AusNet Services Distribution Revised Regulatory Proposal  
2026-31

# REVIEW OF SELECTED AUGEX PROJECTS

Report prepared for:  
AUSTRALIAN ENERGY  
REGULATOR  
March 2026

Figure 4.2: Value of expected energy at risk on Eastern Cranbourne 66kV network loop

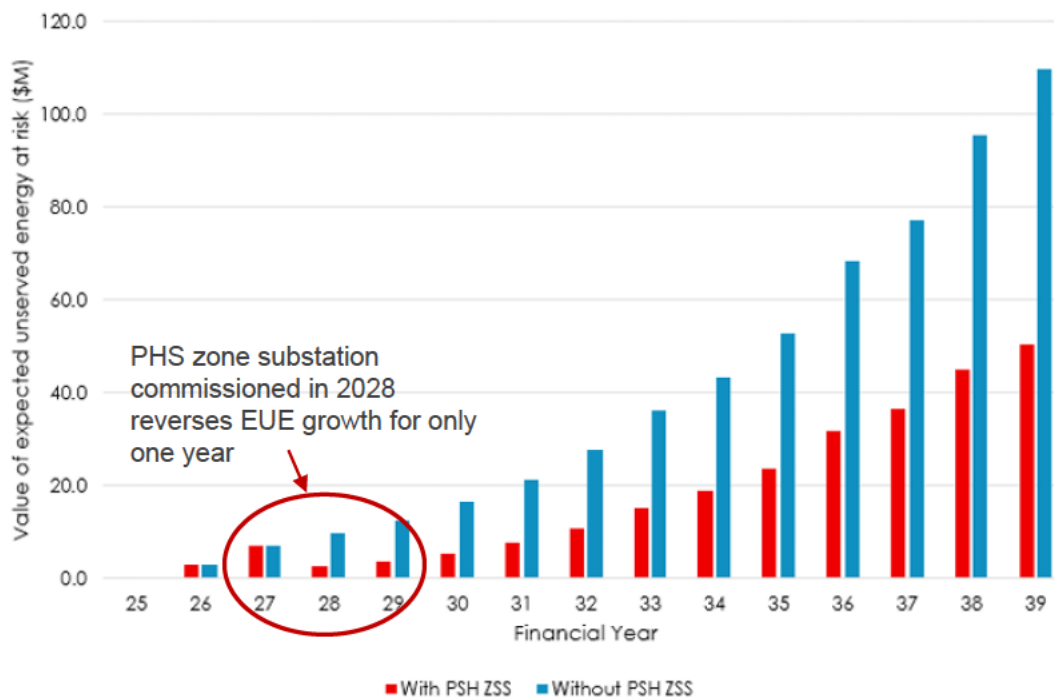
191. With the updated forecast peak demand, PHS still has an impact on EUE, as shown in Figure 4.2, however, the reduced EUE is still higher than the annualised cost of the proposed solution. When combined with the lower annualised capital cost for Option 1, the economic timing is brought forward to 2028.

Figure 4.4: Expected Unserved Energy – East Gippsland 66kV loop – with and without Fulham BESS

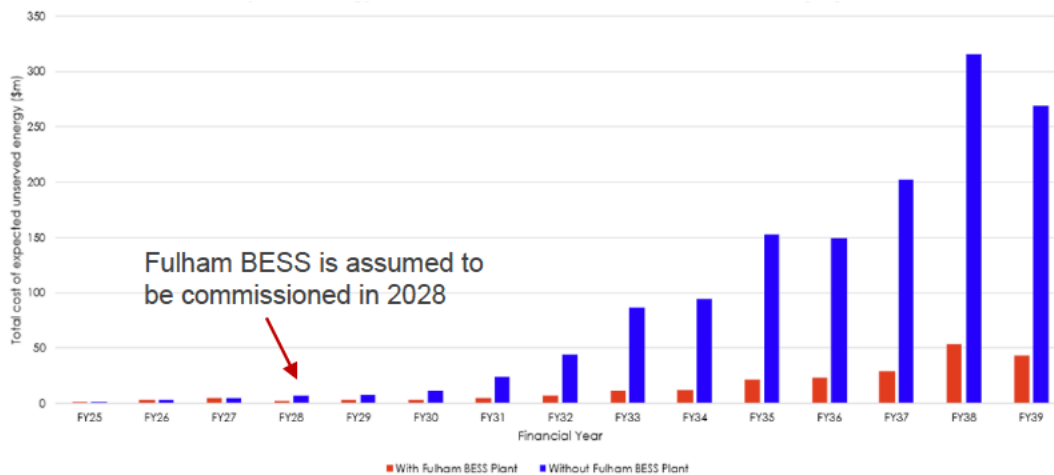
221. The introduction of the Fulham BESS has an impact on EUE, reducing it, as shown in Figure 4.4. This delays the economic timing to FY30, as shown in Figure 4.5.<sup>70</sup>

Figure 4.6: WGI third transformer – economic timing – base case (\$m, real June 2024)

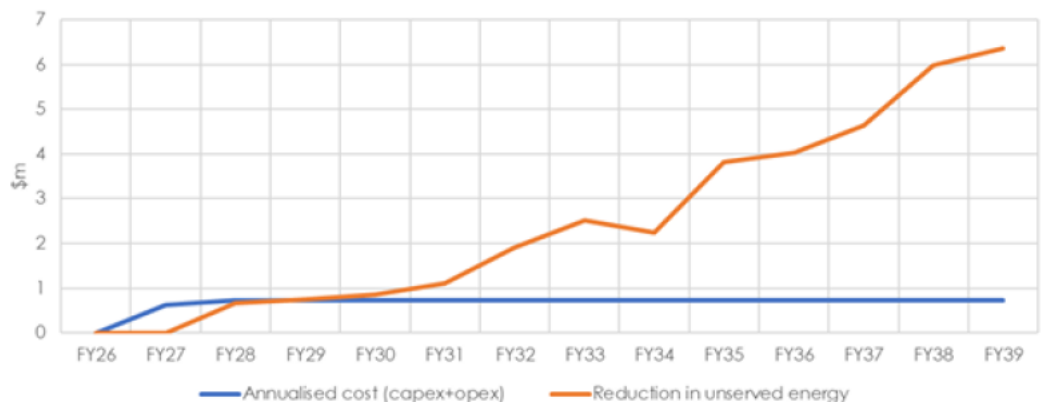
- 237. As shown in Figure 4.6, the PoE50 and PoE10 forecasts have increased considerably, which together with the changes to the WWF contribution, load transfer, cyclic ratings, and inclusion of the PV factors, leads to a significantly higher EUE.
- 238. As shown in Figure 4.6, the economic timing is FY29.

Figure 4.7: WGI - January and updated summer demand forecasts

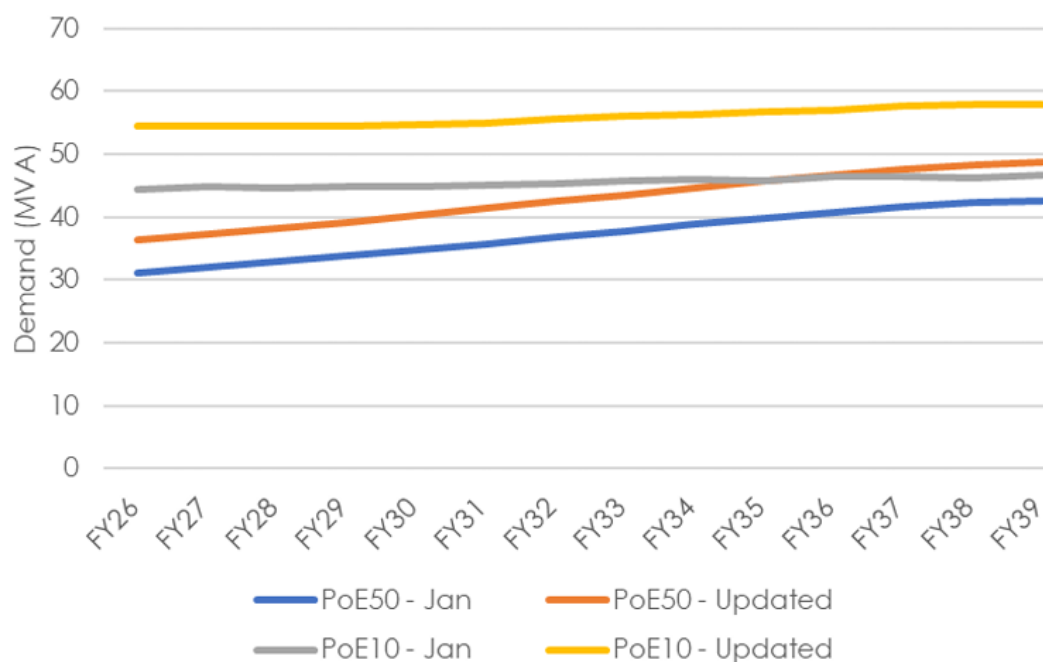
- 239. We have discussed the inclusion of PV factors in Section 3.2.3. The economic timing is deferred from 2029 to 2031 if the PV factors are set to 1.0, with all other things being equal.
- 240. As discussed in Section 3, AusNet’s optimal timing is established by using an annualised cost derived from the PV of the capex (plus opex) which is lower than if the undiscounted capex is used. With the appropriate annualised cost, the economic timing is FY30, with all other factors unchanged, a deferral of one year from AusNet’s base case.

Figure 4.8: New WOTS21 feeder – economic timing (\$m, real June 2024)

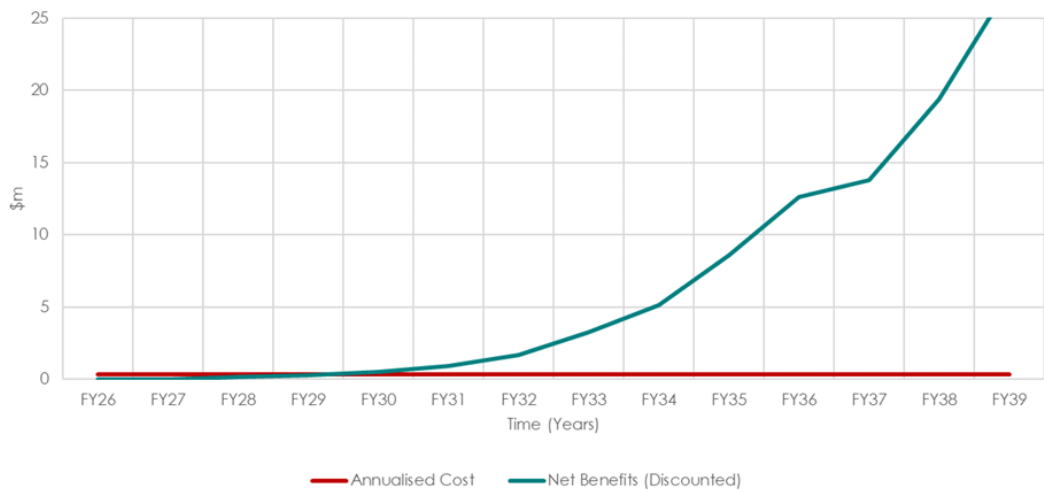
260. The updated summer peak demand forecast for the WOTS25 22kV distribution feeder are somewhat higher than applied in the RP modelling, but these increases are largely offset by the decreases in the winter PoE.<sup>85</sup> The economic timing is now determined to be 2030, which is still within the next RCP, as shown in Figure 4.8.
261. To assess the sensitivity of the economic timing to favourable variances, we used AusNet’s modelled results which show that with the low demand case (90% of the central case), the economic timing is deferred until 2034. The use of discounted annualised cost does not affect the outcome.

Figure 4.9: WGL13 – Load at risk

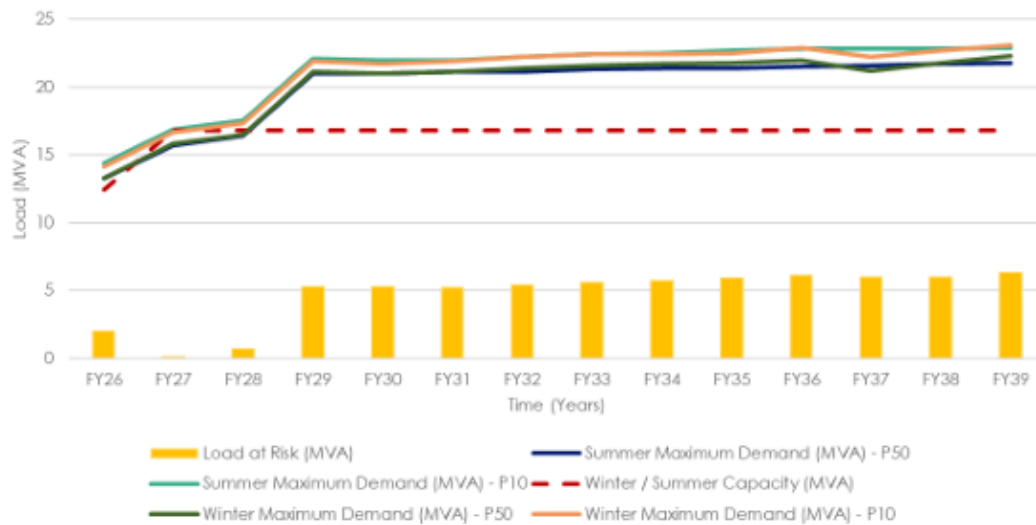
270. The updated forecast demand for WGL13 illustrated in Figure 4.9 shows a step increase in FY29. AusNet notes that it has received:<sup>91</sup>
- ‘...three industrial/commercial customer applications in the cities of Warragul and Drouin in the last year, resulting in a [sic] 11 MVA of additional load, two Electrical Vehicle (EV) charging stations (4 MVA), shopping precinct (1 MVA) and a connection application for the new hospital (6 MVA). All these loads are expected to be fully operational by 2029. Several connection inquiries have also been received for connecting industrial/commercial and residential loads in the area supplied by the same feeders.’*

Figure 4.10: CSIRO -projected total capital costs for 2-hour duration batteries by scenario (battery and balance of plant)

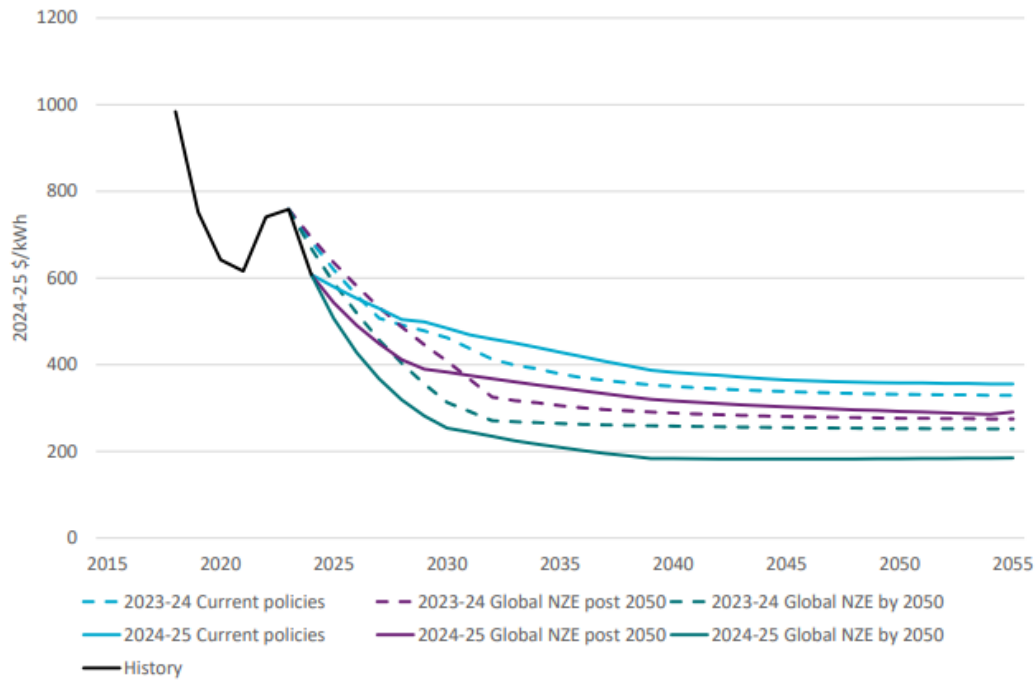
- The CSIRO BESS reference provided by AusNet<sup>108</sup> includes the graph reproduced in Figure 4.10; this indicates that a reasonable unit cost in FY26 for a 10MWh BESS is around \$600/kWh and about \$400/kWh in 2040 including the battery cost and balance of plant.<sup>109</sup> This would translate to:

Figure 4.13: RP versus RRP FY31 PoE10 peak demand forecasts for relevant Southeastern Corridor 22kV feeders

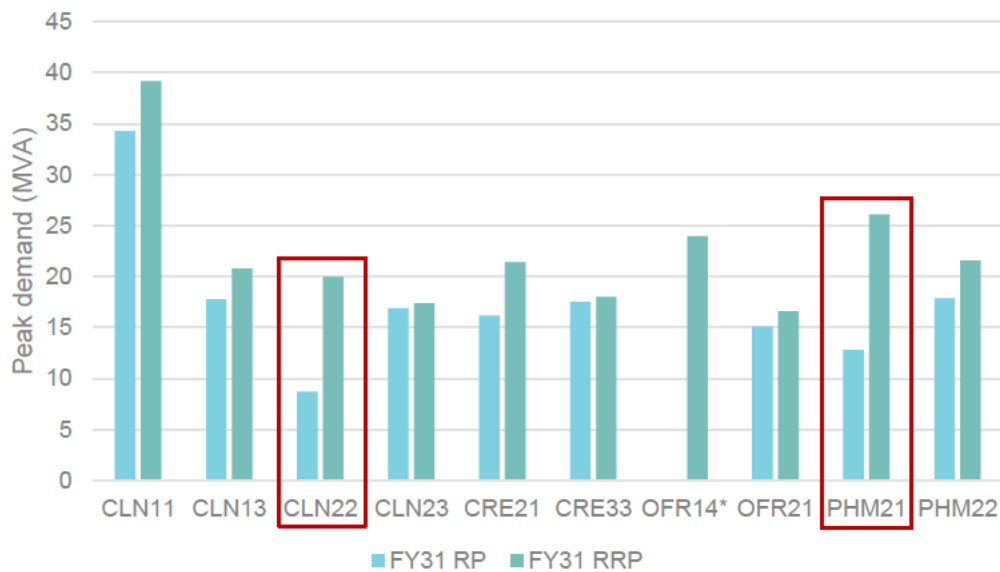
- 320. As shown in Figure 4.13, the demand forecast has increased significantly since the RP, particularly for the CLN22 and PHM21 feeders. Individually and collectively, these overload predictions point to significant existing and growing EAR and probabilistic EUE.

340. It is not apparent from the relatively modest maximum demand increases from the RP to the RRP for these three feeders (illustrated in Figure 4.14) why consideration of augmentation in the next RCP is now required but was not in the RP. In response to an information request, AusNet states that extending or relying on the RP options to service the emerging growth areas would have required disproportionate additional works, undermining their efficiency and deliverability.<sup>126</sup>

Figure 4.18: Greater Clyde South supply area – supply risk - do nothing and Option 2 (2 new feeders)

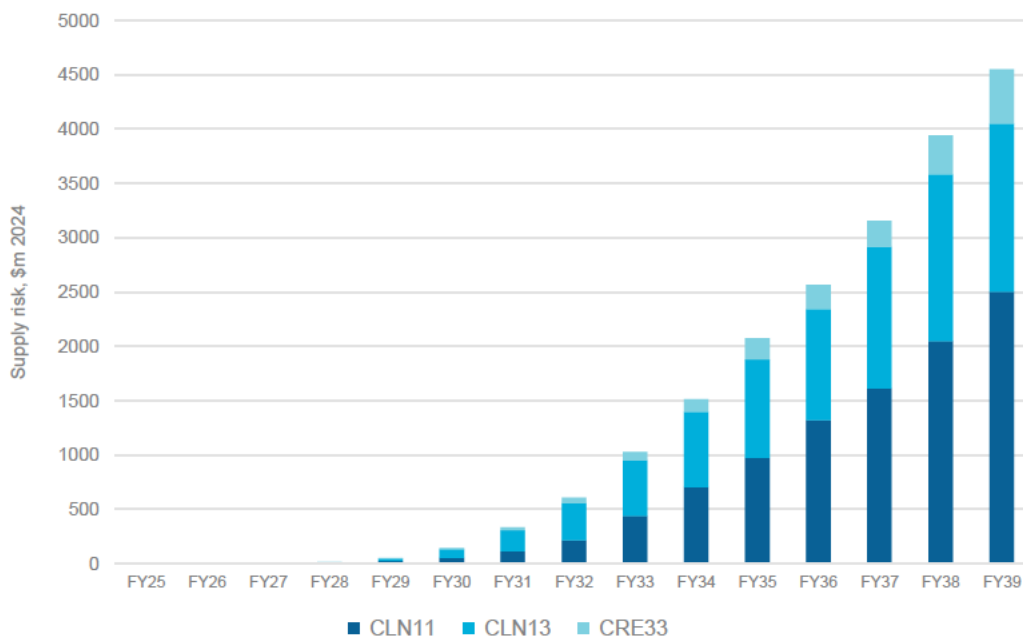
343. Figure 4.18 shows the energy at risk under the ‘do nothing’ scenario. For the incremental cost of the additional feeder compared to Option 1, the avoided EUE is significant. Whilst Option 1 is much cheaper than Option 2, peak demand would exceed the feeder N ratings again within one year.<sup>128</sup> We are satisfied that of the options presented, Option 2 is the prudent choice.

Figure 4.19: Cranbourne West Supply area – supply risk - CRE21 under ‘do nothing’ scenario (\$m, 2024)

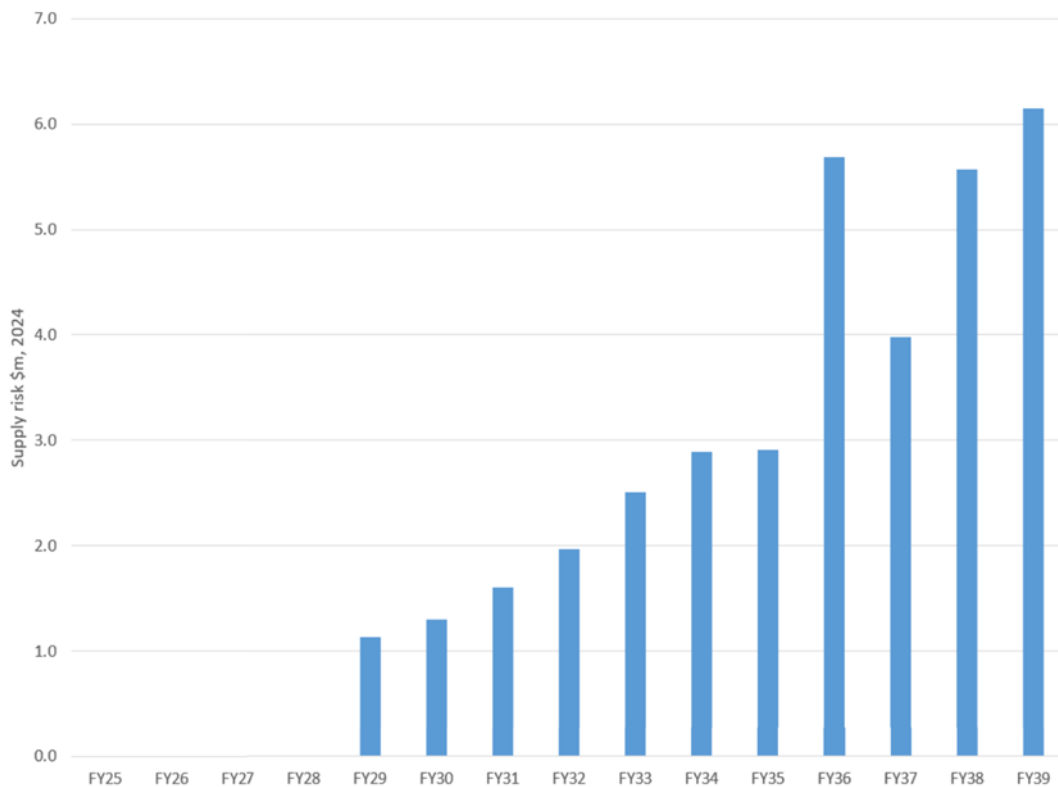
355. Figure 4.19 shows the EAR under the 'do nothing' scenario. The other options reduce the EAR to zero (near zero in the case of Option 4).<sup>138</sup> We are satisfied that, of the options presented, Option 1 is the prudent choice as it addresses the overloading issue for the least cost.
356. The economic timing is FY29, that is, as soon as the peak demand is expected to exceed the N rating. Under the low demand case, the economic timing is deferred until FY32.<sup>139</sup>

Figure 4.23: Forecast demand initial vs. revised proposal – KLO14 and KLO24 feeders (summer PoE10)

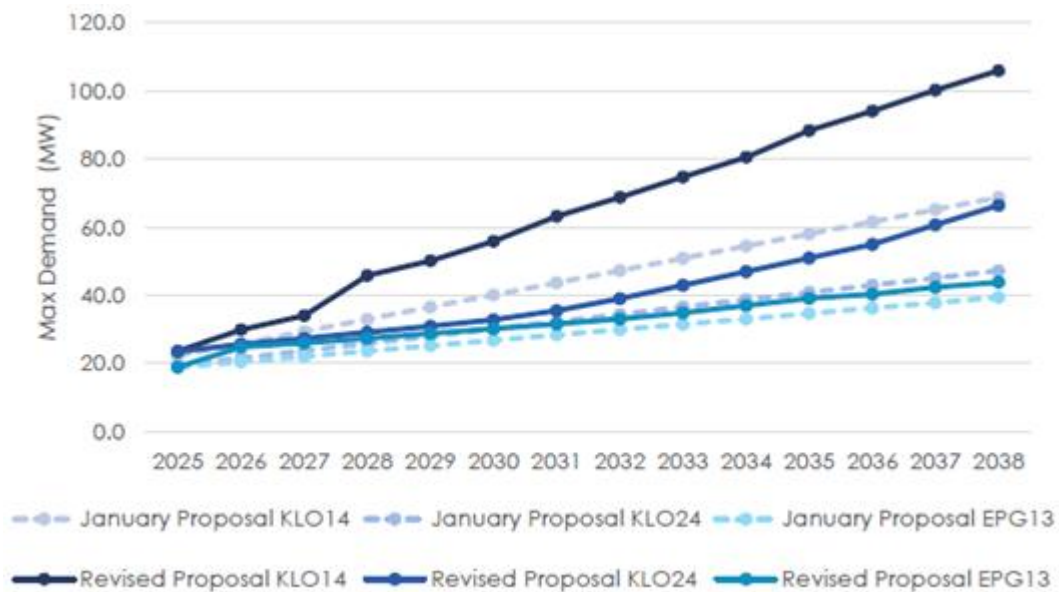
- 390. We also observe that despite what appear to be material increases in demand at the feeder level (as shown in Figure 4.22) there was not a commensurate increase in demand at the substation level. This is best illustrated in Figure 4.23 and Figure 4.24, shared with us during our onsite discussion with AusNet.

Figure 4.27: Comparison of NPV of Option 1 and Option 3 (\$real 2025)

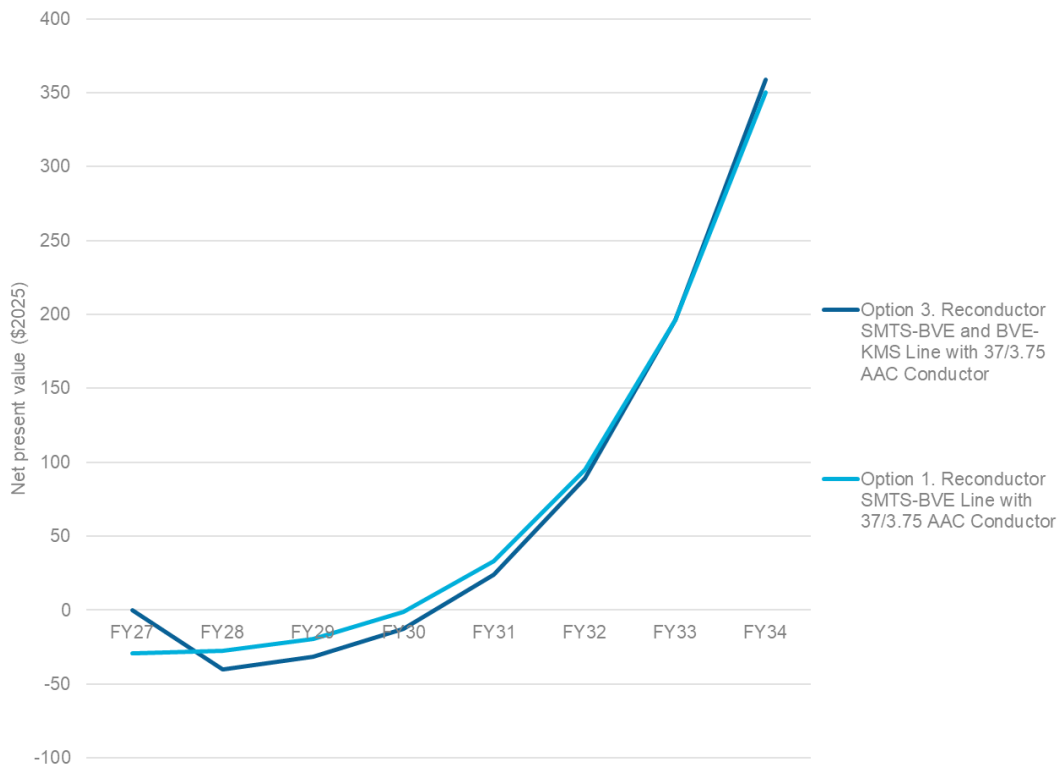
406. We therefore considered whether a lower cost option would be preferable. As shown in Figure 4.27, Option 1, due to its similar benefits and lower cost has a higher NPV until FY34, after which time the NPV of AusNet’s preferred Option 3 is the higher of the two. We understand that from AusNet’s modelling, if an N-1 contingency occurs on the SMTS–BVE line, the BVE–KMS line will become heavily overloaded under these options, and which is not upgraded under Option 1.
407. Based on selecting the option with the highest NPV, Option 3 is the prudent option. This is also supported by our reading of AusNet’s planning standard,<sup>145</sup> which indicates that 37/3.75 AAC conductor (117MVA rating) is the AusNet standard for urban 66kV lines.

Figure 4.30: AusNet's description of its calculation for EUE at Risk

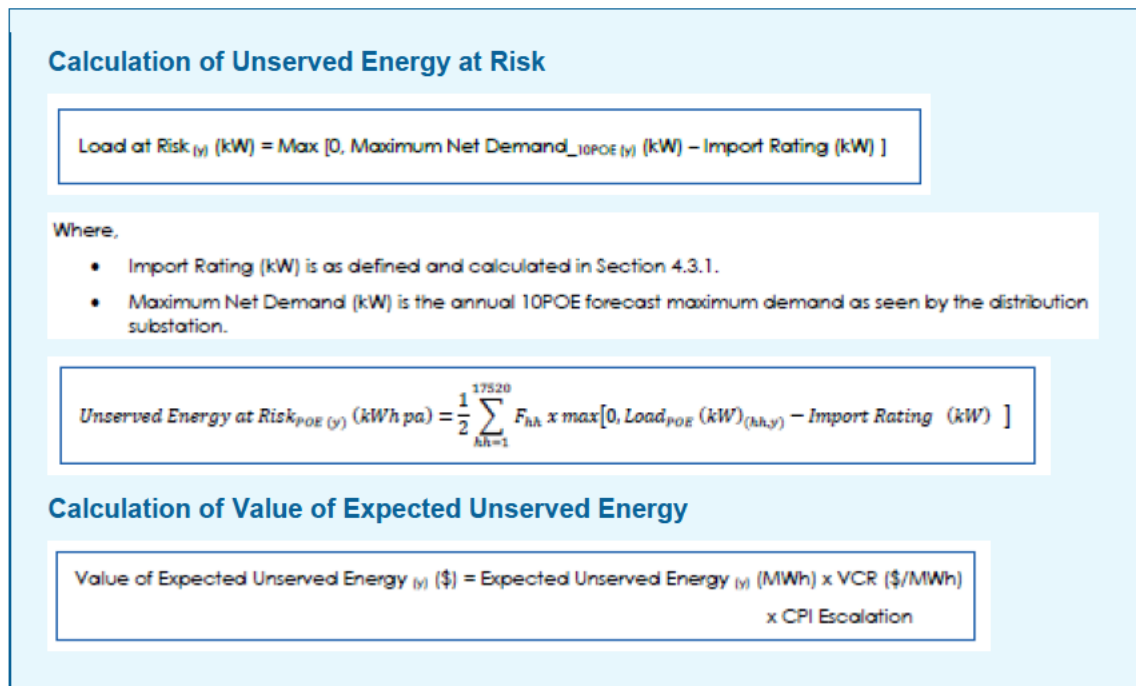
464. Our primary concern with AusNet’s methodology is that it conflates the risk of an outage, with an assumed actual outage, for which it then quantifies a cost based on VCR based on its estimate of the EUE.
465. In its methodology document, AusNet describes its calculation of the value of EUE based on formulas which we reproduce in Figure 4.30.

Figure 4.31: Example load duration curve and energy at risk

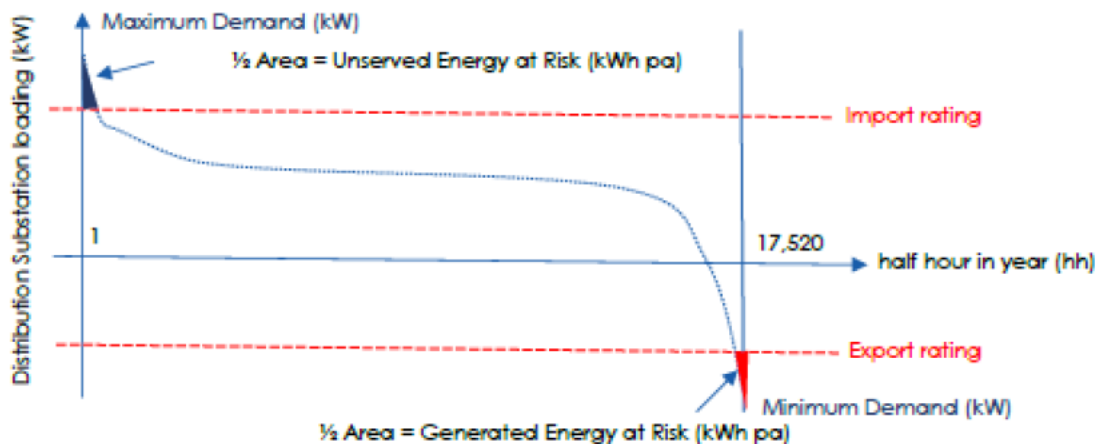
466. AusNet further illustrates its methodology in the diagram that we reproduce as Figure 4.31. We observe from this that AusNet effectively treats as 'unserved' all energy in its forecast load duration curve, above the relevant 'import rating' of the asset.

467. In its methodology document, AusNet defines the 'thermal limitation', which it equates to the 'import rating' referred to in the diagrams above, as '120% of the cyclic rating of the distribution substation's transformers'.<sup>157</sup> We sought further clarification from AusNet as to how it defined the import rating, relative to the description of 'overload' that it included in the diagram that we reproduce as Figure 4.32, and which effectively expands on the 'top end' delineation of Unserved Energy at Risk in Figure 4.31.

Figure 4.34: Distribution substation (DSS) utilisation factors

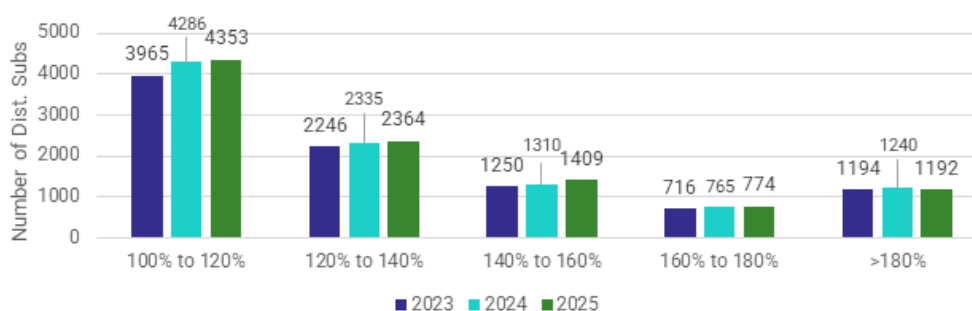
476. We sought to test AusNet's assumption that its' DSS would cease providing supply at utilisation greater than 120%. AusNet provided the information in Figure 4.34, showing the utilisation factors for those substations where it is greater than 100%.
